# ADDENDUM NO. 2

## CITY OF MART WASTEWATER TREATMENT PLANT IMPROVEMENTS

## TEXAS WATER DEVELOPMENT BOARD CWSRF Project No. 73903

**ADDENDUM No. 2**  
**February 18, 2026**

Sheet No. A-601  
 45 of 89  
 Project No. 1397.21002

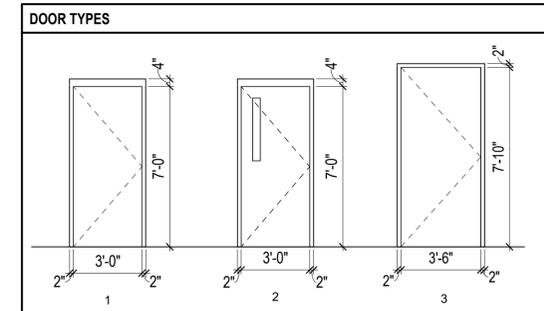
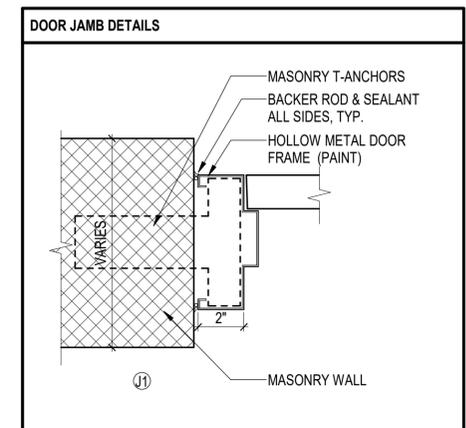
2 Addendum No. 2  
 No. Revisions and Descriptions  
 MNA 2/18/26  
 By Date  
 All Rights Reserved
